Alaska Railroad Corporation
327 W. Ship Creek Ave.
Anchorage, AK 99501

Addendum 1
Invitation to Bid # 20-26-208267
Whittier Yard: Subgrade Drainage Improvements

Addendum number 1 is issued for Questions, Revised Appendix I : Cost Schedule, and the scheduling of a site visit.

DETAIL #
55-4

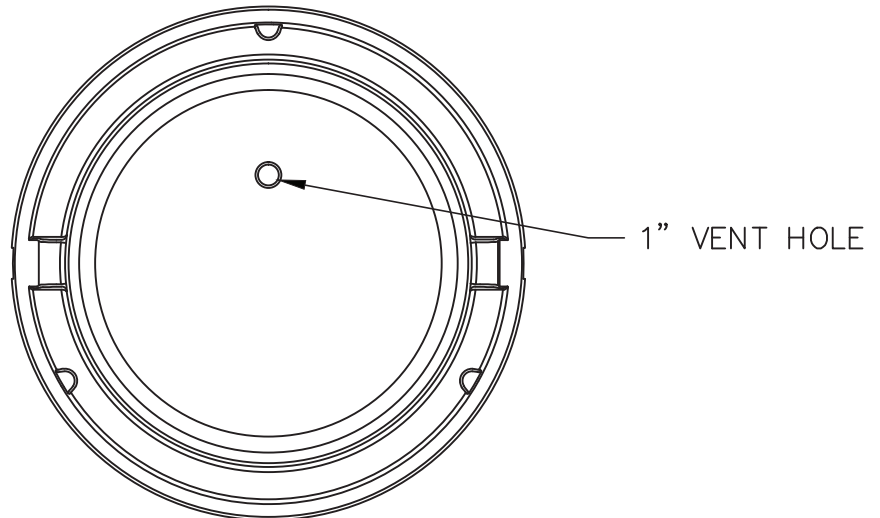
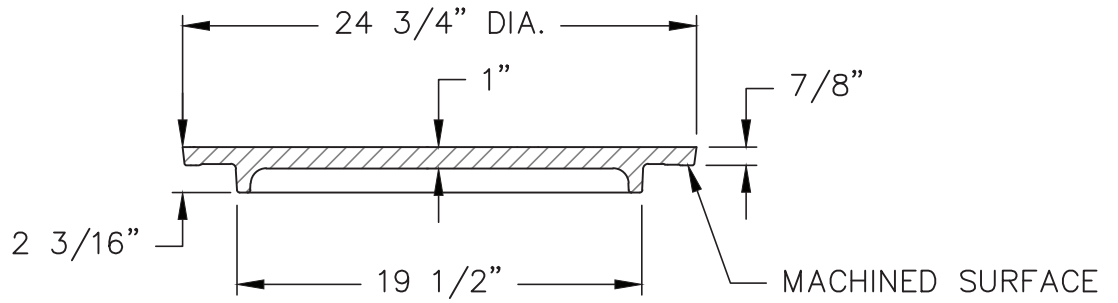
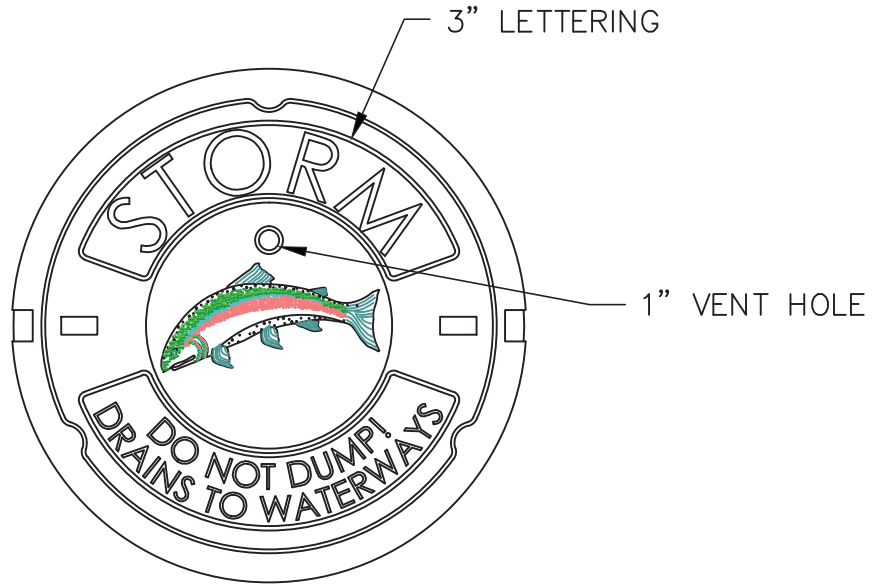
2. Cost schedule calls for 1 Each 48" Precast Manhole. What SDMH is the 48" Precast Manhole? Will the ARRC provide a detail for this structure or will ARRC expect the manufacturer to do so.

- a. **The 48"Ø SDMH is to be placed at ≈Sta. 67+06, 136' RT; see Sheet 3 of 11 and Note 1. The structure itself should be similar to the Municipality of Anchorage (Muni)'s Type 1 Storm Drain Manhole (SDMH) Detail 55-4 with a grate and solid lid similar to the Muni's Detail 55-7. The aforementioned details will be provided and incorporated into the Contract Documents. As the structure is outside the operational driving surface, the structure does not need to be designed to support the design vehicle provided in the Contract Documents. The fabricator will still be required to submit shop drawings for approval by the Owner.**
